**CITY OF CHARLOTTESVILLE
BOARD OF ARCHITECTURAL REVIEW
STAFF REPORT
June 18, 2019**

BAR 19-06-05

605 Preston Place

Parking Lot Expansion

COLLINS ENGINEERING 200 GARRETT STREET, SUITE K. - CHARLOTTESVILLE, VA 22902 - 434.293.3719		PROJECT	
		JOB NO. 172140	
PRESTON APARTMENTS SITE PLAN AMENDMENT # 2		SCALE	
		1" = 10'	
PARKING LOT EXPANSION - LAYOUT, GRADING AND DRAINAGE PLAN		SHEET NO.	
		6 OF 9

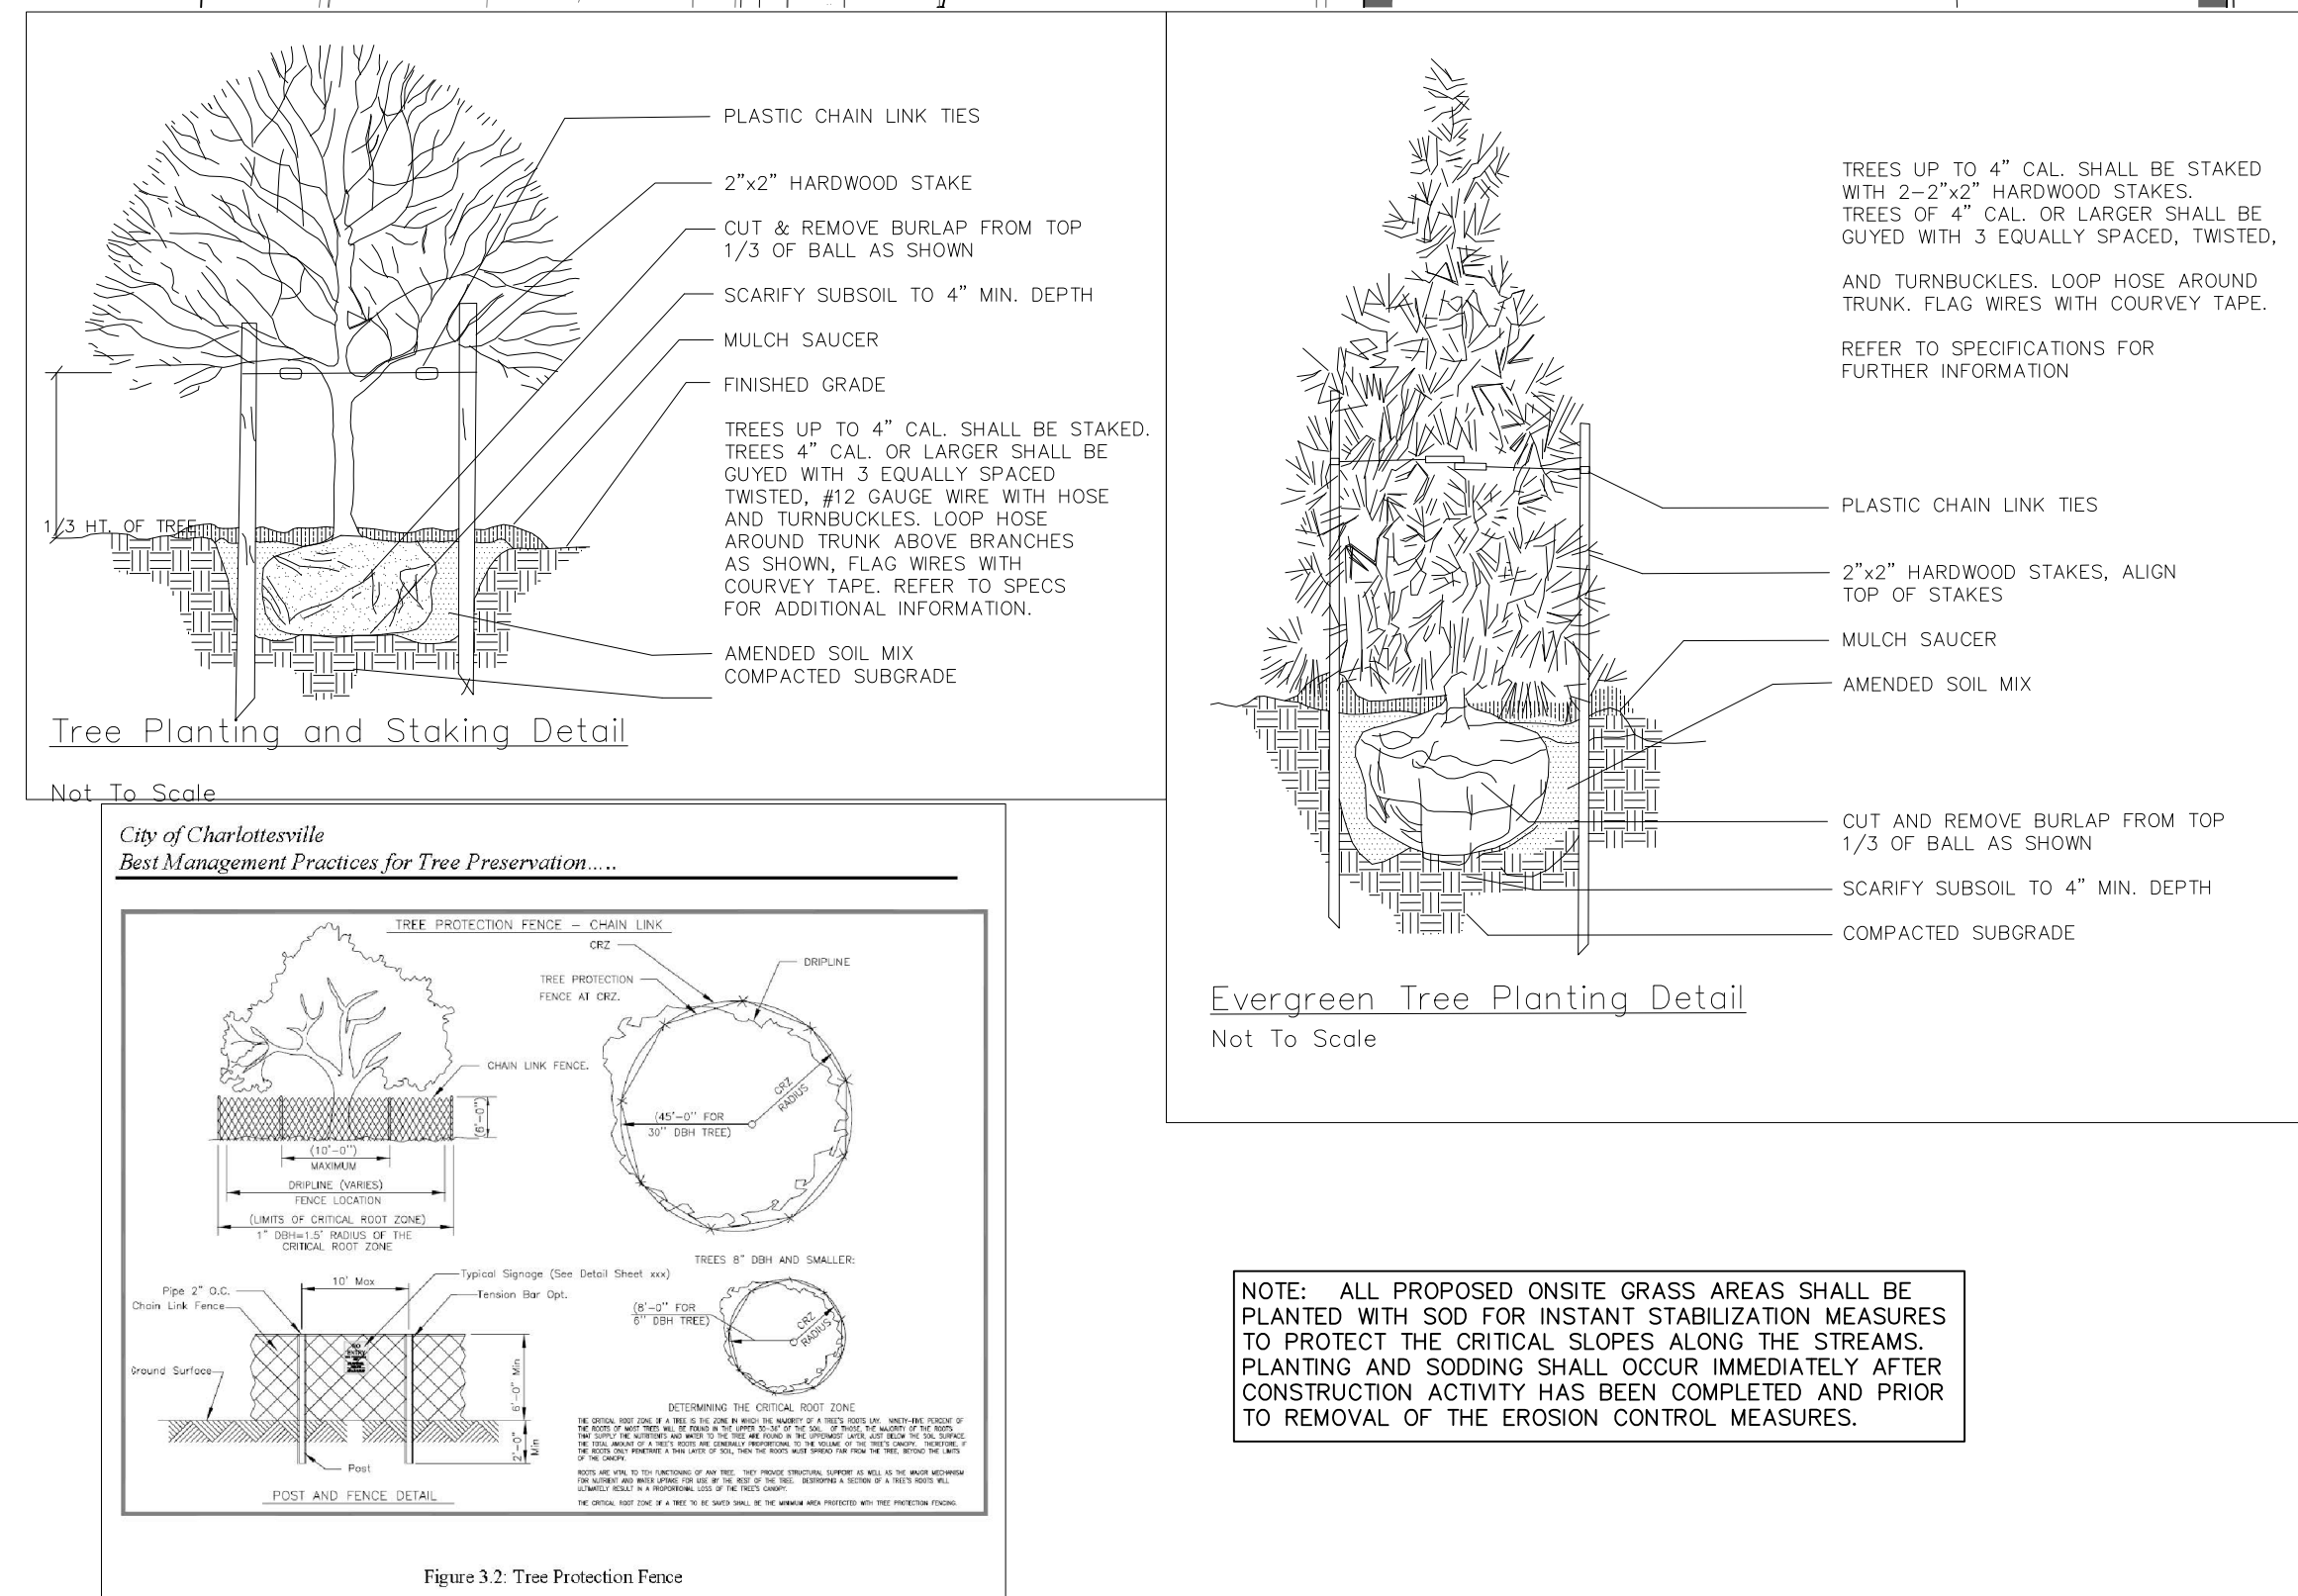
Staff finds the request appropriate since the proposed parking area is appropriately screened and is placed behind the historic structure. Additionally, staff finds the number of trees proposed in the landscape plan appropriate to accommodate for the loss of tree canopy in regard to the removal of the six existing trees.

Regarding the 36 inch oak to remain, staff recommends that the BAR consider a condition of approval that requires the applicant to consult with a licensed arborist to establish—and implement—stringent measures to protect the tree during construction. Such steps might include the installation of rigid fencing to limit—if not preclude—traffic within the entirety of the tree's dripline.
